ITS NRC Questions

Enclosure (1 of 4), Q&A to Attachment 1, Volume 13 (Section 3.8) Page 2 of 41

Attachment 1, Volume 13, Rev. 0, Page 118 of 289 JUSTIFICATION FOR DEVIATIONSITS 3.8.3, DIESEL FUEL OIL, LUBE OIL, AND STARTING AIR JFD #5 STATES, in part: "The KPS CTS does not include any requirements for the Starting Air Systems. Thus, as long as enough air is in each required air start receiver bank to start the DG one time, the pressure is acceptable. KPS has maintained this requirement in the ITS. The SR 3.8.3.4 pressure ensures that the DG can be started at least one time." The KPS USAR states, in part, that the primary or reserve air storage tanks have sufficient storage to crank the DG for twenty seconds. Additionally, the start cycle described in the KPS USAR states that the DG may continue to crank for up to 15 seconds prior to a start failure fault lockout. The proposed KPS ITS 3.8.3 deletes ISTS Condition 3.8.3.E (minimum air start receiver pressure) and proposes a new Condition 3.8.3.E without a minimum air start receiver bank pressure. Bases on the above, explain why the minimum value (≥ 200 psig) for air start receiver bank pressure is not a required condition for TS 3.

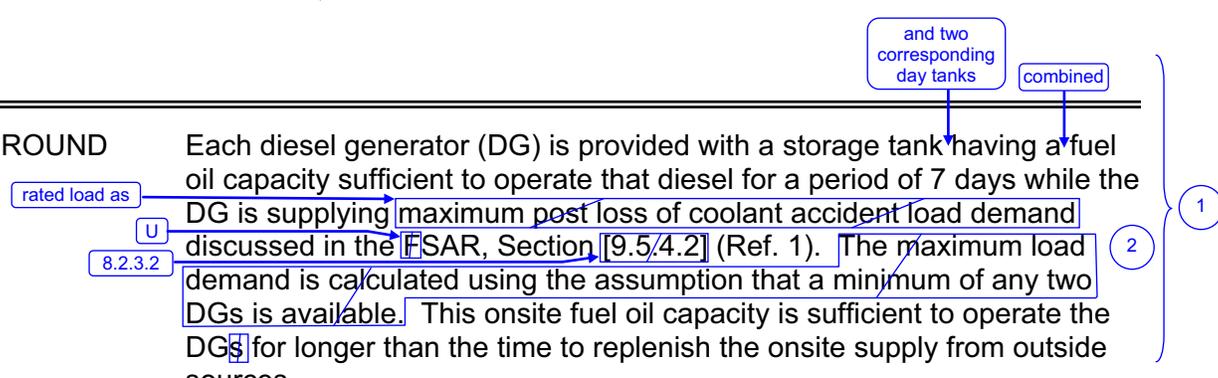
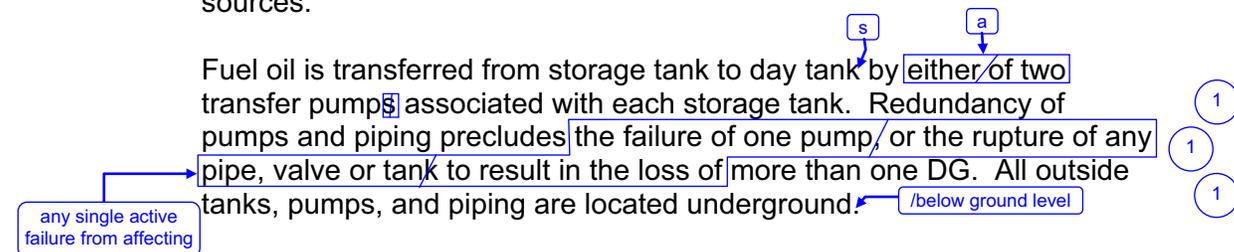
NRC
Question **Attachment 1, Volume 13, Rev. 0, Page 116 of 289 Proposed ITS 3.8.3, Required Action E.2 "NOTE" states as follows: "The cross-tie between the DG Starting Air Systems may be intermittently opened under administrative control to achieve and maintain the inoperable Starting Air System air receiver banks pressure \geq 200 psig." This note is not found in the KPS CTS or in the ISTS. Explain how the above proposed ITS Required Action maintains the independence of the DG starting air system as described in the KPS USAR.**

Response
Statement **After further discussion, DEK has decided to delete the Note to ITS 3.8.3 Required Action E.2. In doing so, the OPERABLE starting air compressor will not be allowed to be used to recharge the air start receivers associated with the inoperable compressor. If it is used, then both air start systems would be considered inoperable and appropriate ACTIONS entered (i.e., ITS 3.8.3 ACTION F). A draft markup regarding this change is attached. This change will be reflected in the supplement to this section of the ITS conversion amendment.**

Response Statement **After further review and informal discussions with the NRC, KPS has determined that current licensing basis will be maintained with respect to diesel starting air. Therefore, the starting air requirements, including the air compressor and the air receiver pressure, will be removed from the ITS submittal. A draft markup regarding this change is attached and supersedes the markup provided in the second response to this RAI. This change will be reflected in the supplement to this section of the ITS conversion amendment.**
